Access Compliance Report Public Rights-of-Way (Pedestrian Signals)

Main Street: YORBA_LINDA_BLVD Cross Street: YORBA_LINDA_BLVD Location: SW

ADA ID: SGAT210923080540 Signal Type: One Push Button-Non APS Overall Compliance: No Severity Scores: BTN 1: 35 BTN 2: N/A No BTN: N/A

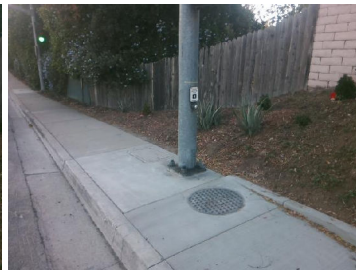
Surveyor Notes: Manhole in clear space

OC Std/PROW: MUTCD 4e.08, R404.2, R404.3

Possible Solutions: Replace Signal Push Button With APS Button. Remove & Relocate Sign.
